Northwest District Association

RE: EA 15-125425 DA – Block 290 - Slabtown Square

South building - current proposed massing

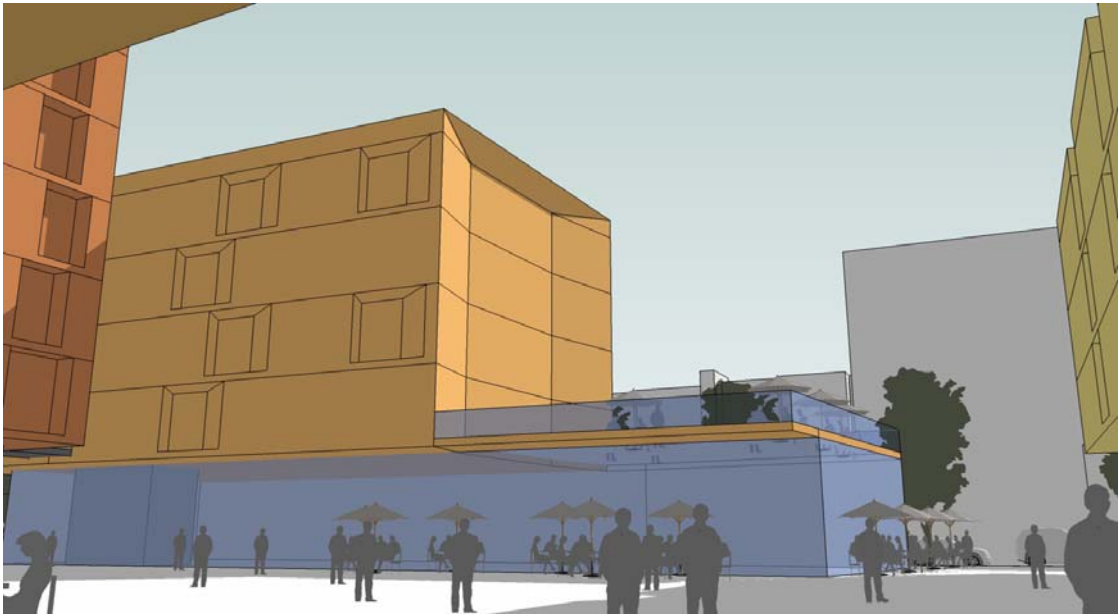
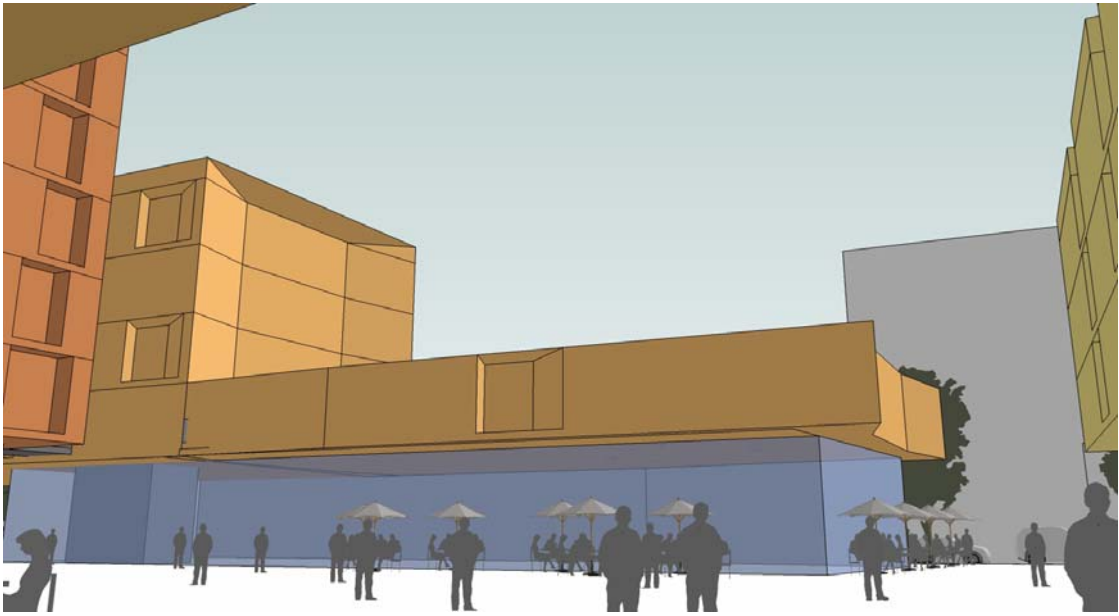
2. **Building Heights.** The height of the east and south buildings is not supported; the buildings need to be lowered to allow adequate sunlight and an appropriate scale of the enclosing facades. The East building needs to be lowered to 5 floors, or the top floor needs to step back at least 8' on all four sides. The South building's 5 floor portion western face needs to align to the western face of the East Building, and a second floor added over the one floor portion. See page 3;

South building - preferred alternative massing
